Access Compliance Report

Public Rights-of-Way

Intersection ID: 46917	Main Street: RAISIN_TREE_LN	Cross Street: MONARCH_BIRCH_LN	Location: SE
ADA ID: E348AAE85A46	Ramp Type: PerpDiag	Initial Pass/Fail: Fail	Overall Compliance: No
Severity Score: 22.5			
Codes/Mitigation Info/Possible Solution		Field Measurements/Component Compliance

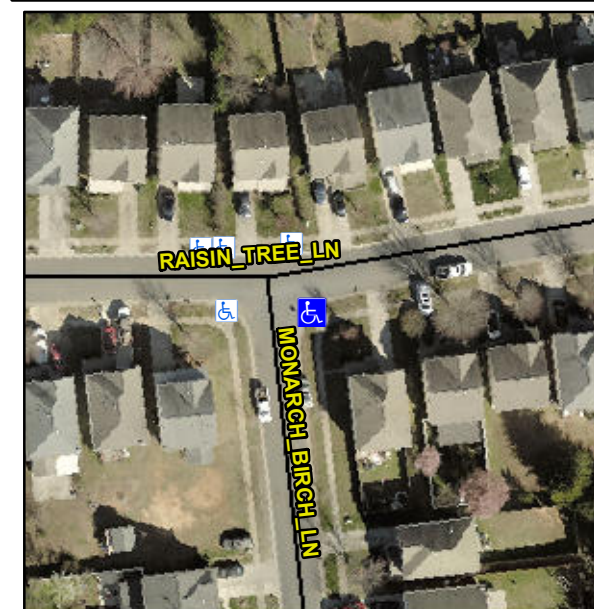
Not Found, R304.5.1, R304.2.2, R304.5.3

Compliance	Description	Data	Compliance	Description	Data
N/A	Ramp Length (in)	86.5	No	Ramp Slope (%)	10.0
No	Ramp Width (in)	47.0	No	Ramp XSlope (%)	4.7
N/A	Flare Type LT	N/A	N/A	Flare Type RT	N/A
N/A	Flare Slope LT (%)	N/A	N/A	Flare Slope RT (%)	N/A
N/A	Flare Traversable LT?	N/A	N/A	Flare Traversable RT?	N/A
N/A	Landing Length (in)	N/A	N/A	DWS Provided?	N/A
N/A	Landing Width (in)	N/A	N/A	DWS Contrast?	N/A
N/A	Landing Slope (%)	N/A	N/A	DWS Length (in)	N/A
N/A	Landing X Slope (%)	N/A	N/A	DWS Full Width?	N/A
N/A	Landing Curb? (Y/N)	N/A	N/A	DWS Offset (in)	N/A
N/A	Shared Landing?	N/A			
N/A	Gutter Ponding?	N/A	N/A	Gutter Slope (%)	N/A
N/A	Gutter Lip Ht (in)	N/A	N/A	Gutter X Slope (%)	N/A
N/A	Painted X Walk1?	No	N/A	Painted X Walk2?	No
	X Walk 1 Direction	To N		X Walk 2 Direction	To W
N/A	X Walk 1 Width (in)	N/A	N/A	X Walk 2 Width (in)	N/A
	X Walk 1 Slope (%)	2.0		X Walk 2 Slope (%)	3.7
	X Walk 1 X Slope (%)	6.0		X Walk 2 X Slope (%)	0.1

Remove & Replace Curb Ramp With Two New Directional Ramps or Equivalent.
